Daimler Buses

TI No.: 83.10T24281A

TITLE: **Tourrider USA - Replacing the operating levers of the emergency exit hatches**

M83.10-A019-80

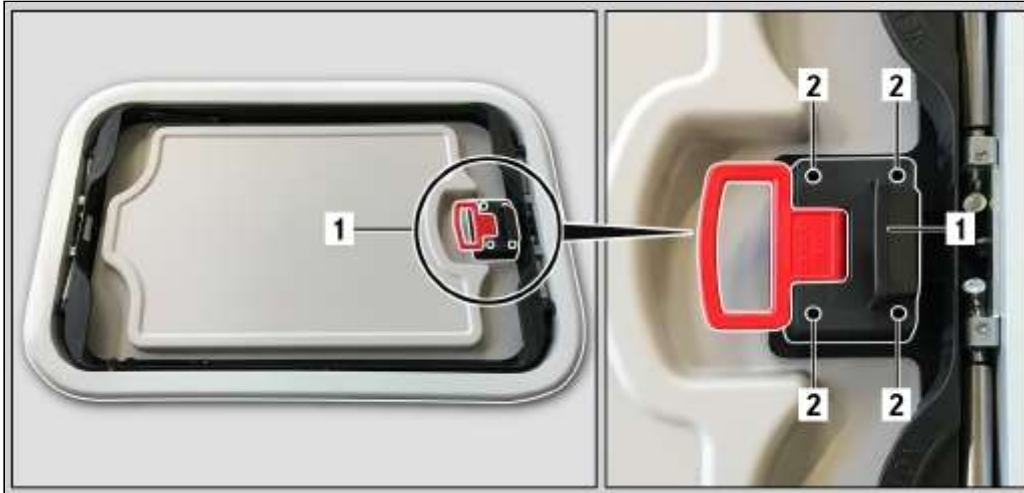
The operating levers of the emergency exit hatches could break.

Inadequate material strength of the operating levers.

Fit an optimised version of the operating levers.

1. Remove screws **(2)**.
2. Remove operating lever **(1)**.
3. Fit the new operating lever and fasten in place.

2 Nm

4. Open and close the emergency exit hatch 2-3 times to ensure trouble-free operation.
